EES Inquiry and Advisory Committee Report

Mordialloc Bypass Project

2 May 2019

Figure 2 2031 two-way daily light vehicle volume difference plot (2031 freeway configuration minus 2031 Base Case)¹²

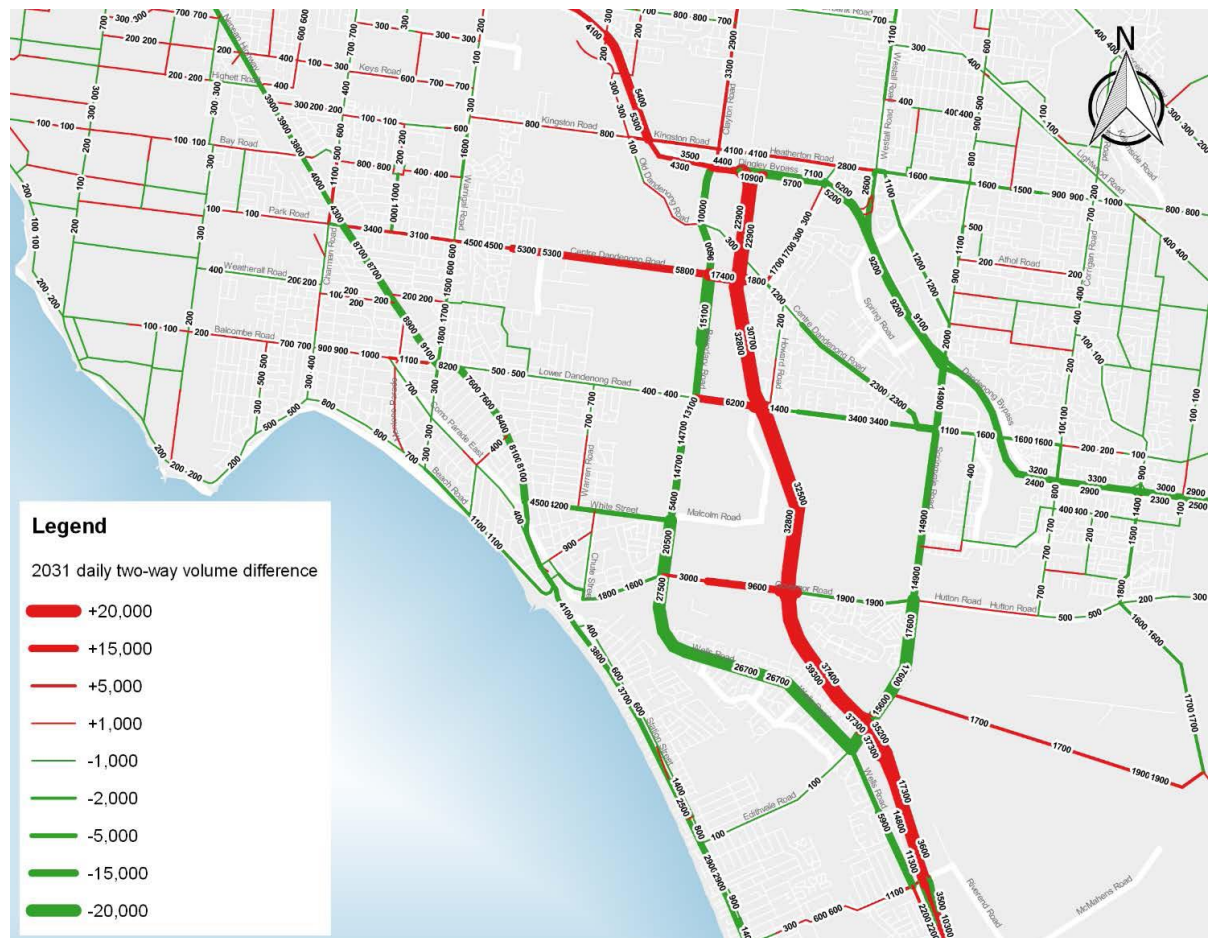
Figure 2 shows the difference in traffic volumes with and without the freeway in 2031. The Figure shows light vehicles only, but the heavy vehicle projections are similar.

- daily traffic volume is estimated to increase along Mornington Peninsula Freeway, east of Springvale Road, by more than 40 percent in the arterial road configuration and by more than 60 percent in the freeway configuration
- daily traffic volume is estimated to double along Centre Dandenong Road, west of Mordialloc Bypass. The impacts of the arterial road configuration are expected be even greater (228 percent) due to the full northbound and southbound access at Mordialloc Bypass
- daily traffic volume is estimated to increase along Governor Road, west of Mordialloc Bypass, by more than 50 percent in the freeway configuration and nearly 90 percent in the arterial road configuration.

Figure 5 Bridge over Mordialloc Creek showing No-go Zones

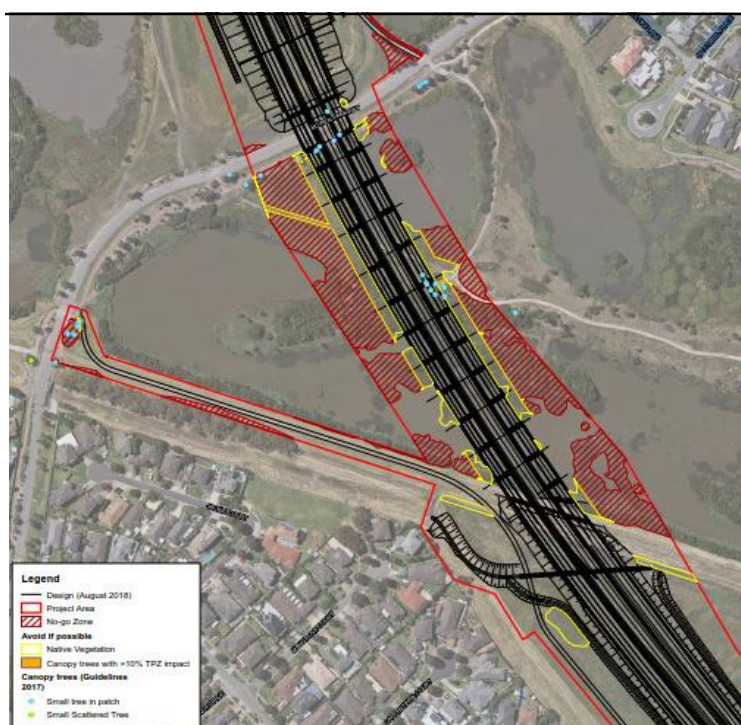
To minimise removal of native vegetation and large trees and disturbance to habitat environments, MRPV propose work buffer areas of eight to ten metres as 'No-go Zones', including in the vicinity of the bridge works as shown in Figure 5 below²⁰.

Figure 6 MRPV proposed extent of HO104

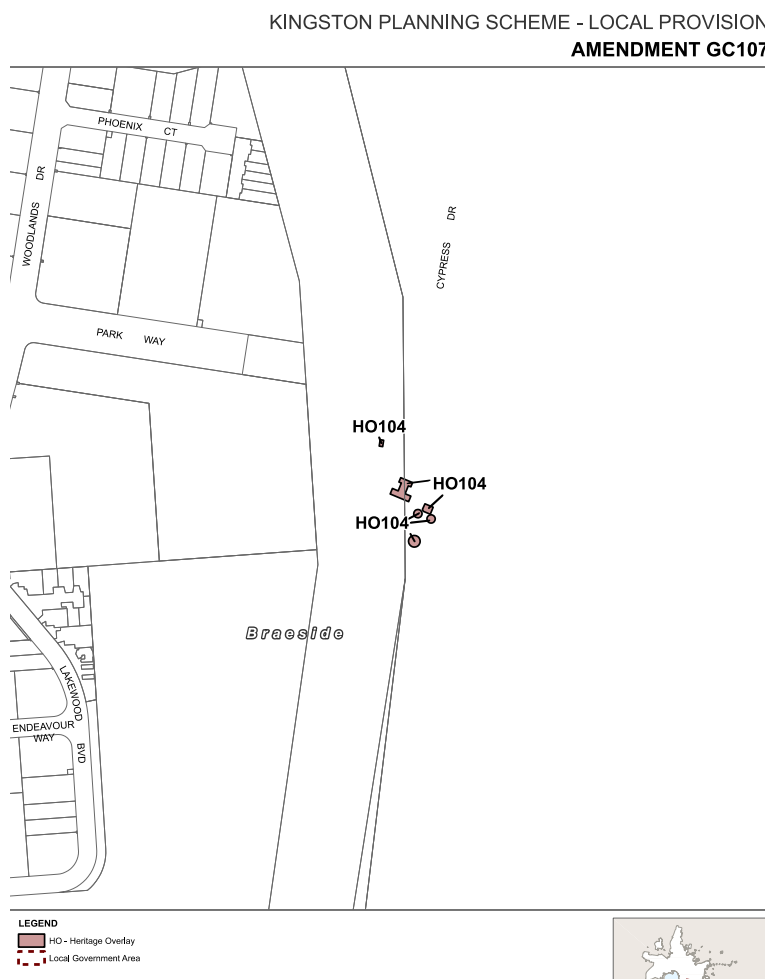
During the course of the Hearing, MRPV provided a revised HO104⁷⁵. The correction proposed by MRPV will apply HO104 to the two brick MMBW buildings (administrative and chlorine store) and key associated infrastructure such as the concrete tanks and treatment ponds located outside of the Project area (refer to Figure 6 below).

Council requested that the HO104 extent also include areas of curtilage, a stand of trees and sewerage infrastructure⁷⁶. Council's position is that there has been no updated assessment provided which supports decisions to leave out any particular elements.

Figure 8 EPBC Act listed flora and communities and No-go Zones

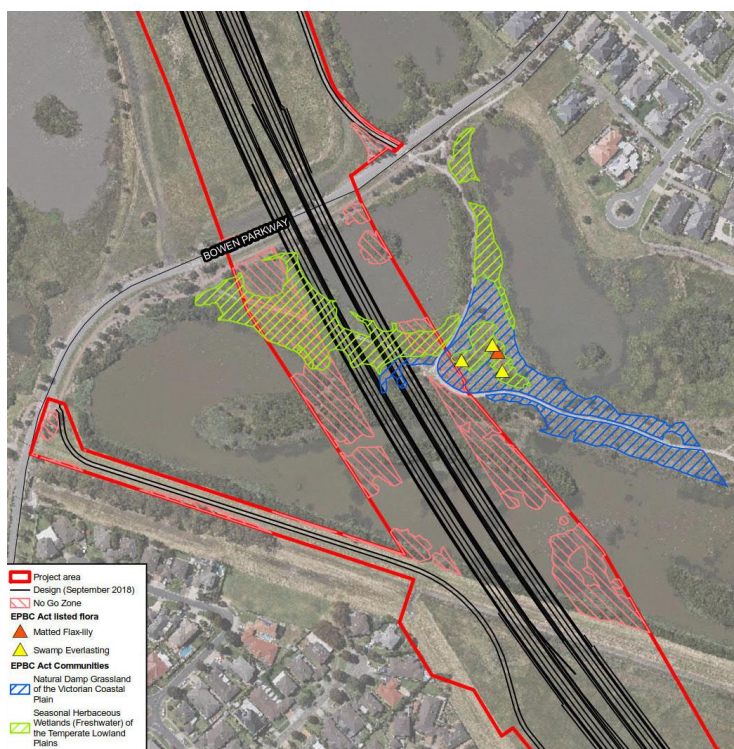
Figure 22.10 of the EES presents the EPBC Act listed flora (Swamp Everlasting and Matted Flax-lily) and ecological communities within and adjacent to the Project area and an extract of that figure is presented below:

The EES stated that the impacts on Seasonal Herbaceous Wetlands (Freshwater) of the Temperate Lowland Plains and Natural Damp Grassland of the Victorian Coastal Plains are not likely to be significant and can be managed by rehabilitation and revegetation with shade tolerant species and re-establishment of landform and substrate underneath the bridge to facilitate this as required in EPR B1 and B5.
